ELVIN MCCORVEY MEMORIAL WATER PRODUCTION FACILITY  
FORMERLY WEST WATER TREATMENT FACILITY, BOOSTER STATION AND GAC  
SYSTEM

ECUA PROJECT NUMBER RW819

BID NO. CC2024-02

**ADDENDUM NO. 3**

## RETAINING WALL DETAIL

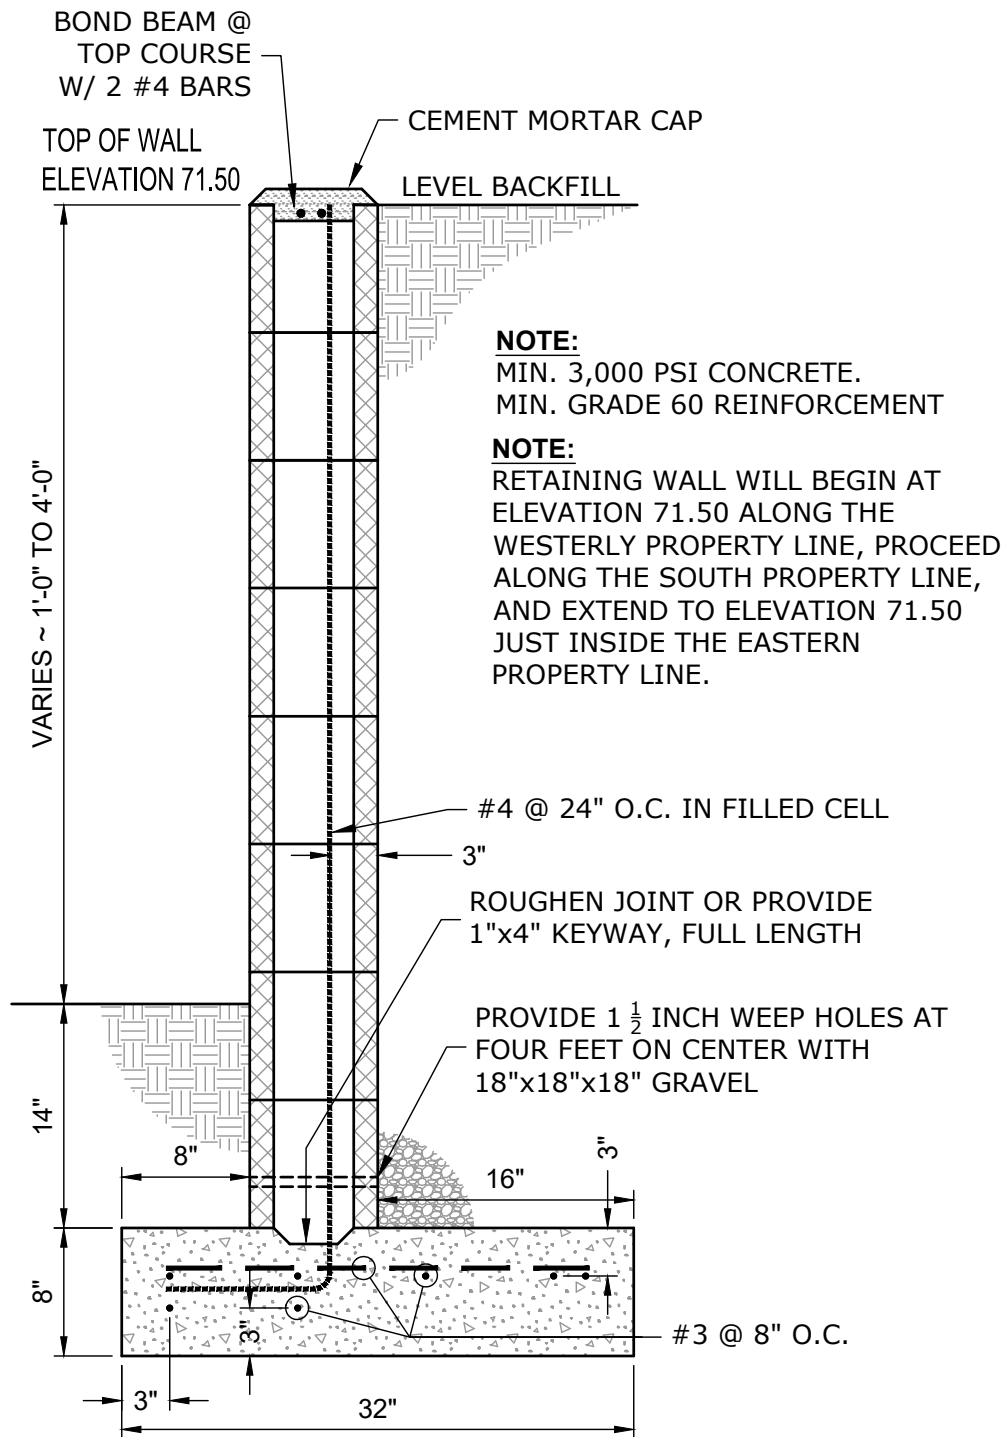
3. Looking at Sheet C-601 south side retaining wall does not have any grade listed for the top or wall and top of footing.

Response: Detail 5, Sheet C-804 has been revised to add data to the retaining wall detail. The revised detail is included in the Addendum.
